SUBJECT: INITIAL EXAMINATION REPORT NO. 50-150/OL-06-01, OHIO STATE
UNIVERSITY

U. S. NUCLEAR REGULATORY COMMISSION
OPERATOR LICENSING INITIAL EXAMINATION REPORT

Comments on SRO License Exam
for Kevin Herminghuysen Proctored on 05-23-2006
OSU Nuclear Reactor Lab - Docket # 50-150

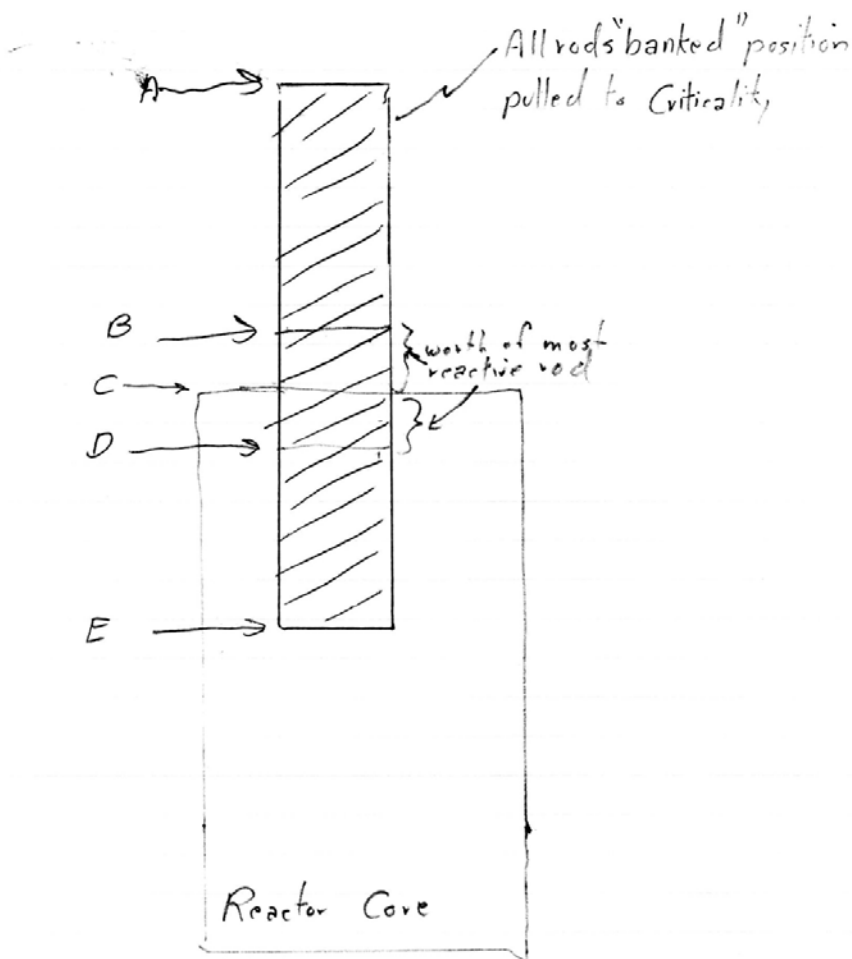
A.14 The figure drawn for this question appears to have been lettered backwards relative to the answers given in the key (i.e. lettered A to E from top-to-bottom instead of bottom-to-top). Based on the figure provided (shown below), the correct answers for parts b through d should be:

- b. 2 (C - A)
- c. 1 (B - A)
- d. 5 (E - C)

NRC Resolution: All comments accepted as written.
